## Video Products Technical Bulletin 30-2016-101

DATE: **October 24, 2016**SUBJECT: **PARTS REGISTRATION—CPU BOARD COMPL**MODEL: ***BKM-XP1***  
**BKM-XP1**SERIAL NO: **ALL***Italicized information in green applies to customers outside the United States.***DESCRIPTION**

**Figure 1**

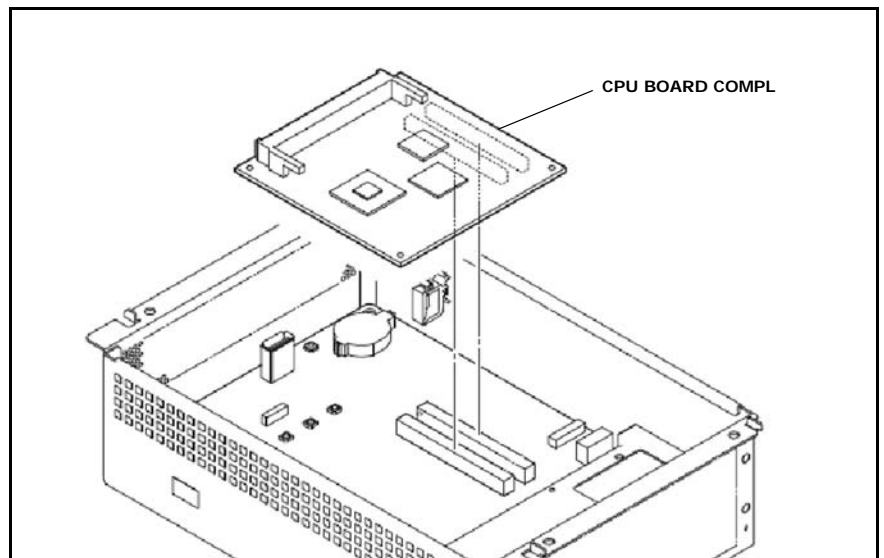
The CPU board is available as a service part. (See Figure 1.)

**NOTE:** When replacing the CPU board, use the service part board above, which has the correct BIOS for proper operation. If the CPU board (1-895-380-11) described in the service manual is used, the player will start, but playback may not function properly.

Description	Part No.
CPU board COMPL	A-2040-045-A
